DENNEY AEROCRAFT COMPANY

KITFOX SERVICE LETTER # 8

SUBJECT: LIFT STRUT MODIFICATION

TO: KITFOX OWNERS WITH SERIAL NUMBERS 02 THROUGH 116

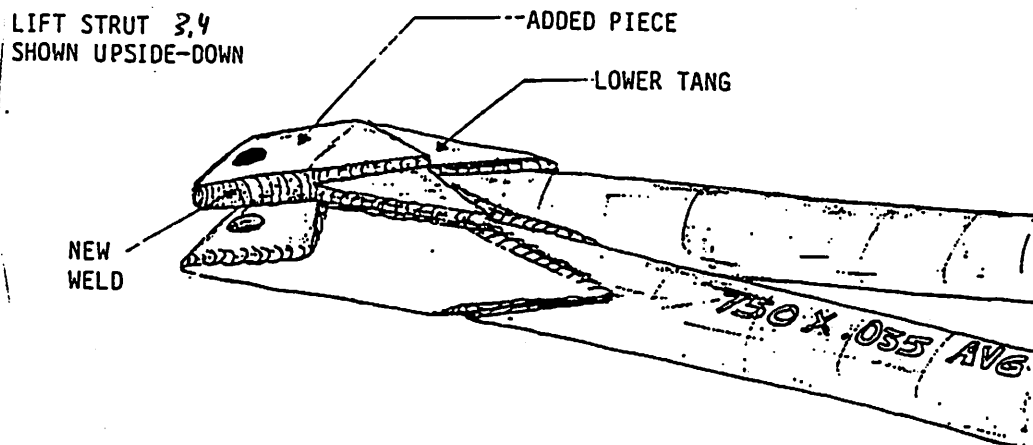
LIFT STRUT MODIFICATION. We have designed a new stronger spar for the KITFOX that enables us to raise the gross weight to 950 pounds. In doing this, we had an outside engineering firm additionally analyze the lift strut and lift strut attach point. The attach point on the fuselage is well above necessary strength values. The lift strut lower clevis may not be sufficient for 6 g's at 850 lbs gross, however. If the material is at minimum specs and the edge distance of the hole in the lower tang is marginal, the strut could fail at 4 1/2 g's.

We have designed a modification that can be made to your lift strut which will ensure 6 g's plus at 850 lbs gross. It is a piece of .090" 4130 steel plate that is welded on to the lower tang of the lift strut. We recommend that you install this to your aircraft. Otherwise, you should placard the aircraft for not more than 4.5 g's positive. It will also require an AN5-10 bolt instead of the AN5-7 that was included in the kit.

This modification can be installed after the speed fairings and fabric are on. Hold a wet cloth around the fabric next to the weld area to prevent it from melting back. The part can be welded on with oxy-acetylene, TIG, or MIG welding process. The welded area should be annealed afterwards.

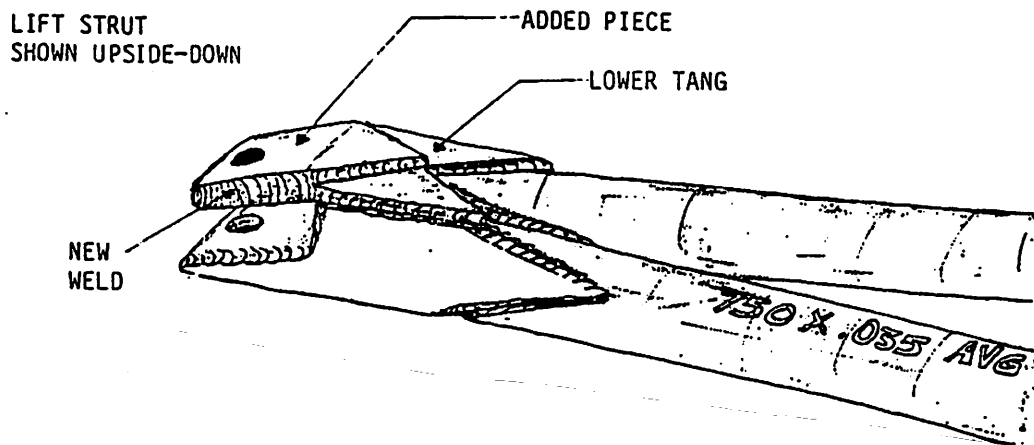
LIFT STRUT MODIFICATION. We have designed a new stronger spar for the KITFOX that enables us to raise the gross weight to 950 pounds. In doing this, we had an outside engineering firm additionally analyze the lift strut and lift strut attach point. The attach point on the fuselage is well above necessary strength values. The lift strut lower clevis may not be sufficient for 6 g's at 850 lbs gross, however. If the material is at minimum specs and the edge distance of the hole in the lower tang is marginal, the strut could fail at 4 1/2 g's.

We have designed a modification that can be made to your lift strut which will ensure 6 g's plus at 850 lbs gross. It is a piece of .090" 4130 steel plate that is welded on to the lower tang of the lift strut. We recommend that you install this to your aircraft. Otherwise, you should placard the aircraft for not more than 4.5 g's positive. It will also require an AN5-10 bolt instead of the AN5-7 that was included in the kit.

This modification can be installed after the speed fairings and fabric are on. Hold a wet cloth around the fabric next to the weld area to prevent it from melting back. The part can be welded on with oxy-acetylene, TIG, or MIG welding process. The welded area should be annealed afterwards.
